SUBJECT: EXHAUST NOISE			No: TSB-03-15-002
			DATE: December, 2003
			MODEL: See below
CIRCULATE TO:	<input type="checkbox"/> GENERAL MANAGER	<input checked="" type="checkbox"/> PARTS MANAGER	<input checked="" type="checkbox"/> TECHNICIAN
<input checked="" type="checkbox"/> SERVICE ADVISOR	<input checked="" type="checkbox"/> SERVICE MANAGER	<input type="checkbox"/> WARRANTY PROCESSOR	<input type="checkbox"/> SALES MANAGER

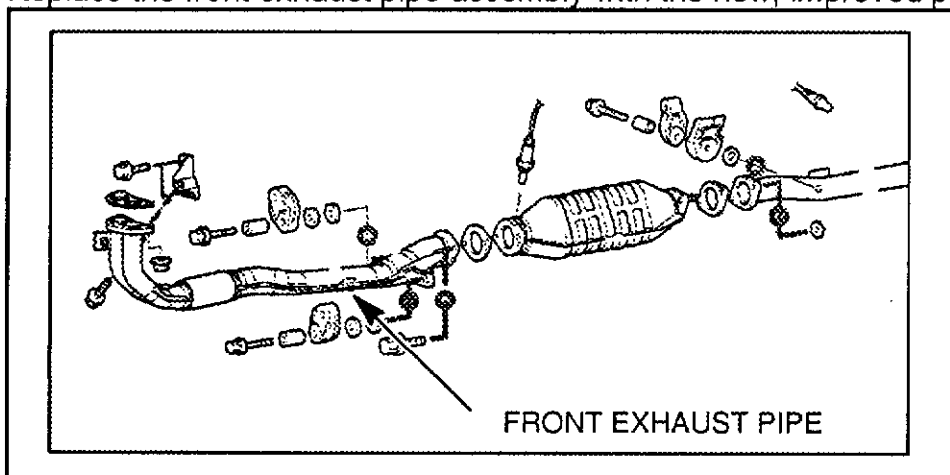
Some affected vehicles may experience abnormal exhaust noise during acceleration. Customers may describe the noise as "like marbles in the exhaust" or "a pinging noise." This noise may be due to the mix of exhaust gases resulting from the internal construction of the front exhaust pipe. Installing a new front exhaust pipe assembly with modified internal construction will prevent the noise. The internal design of the new front exhaust pipe corrects the exhaust gas flow for optimum noise reduction.

Replace the front exhaust pipe assembly with the new, improved parts listed below.
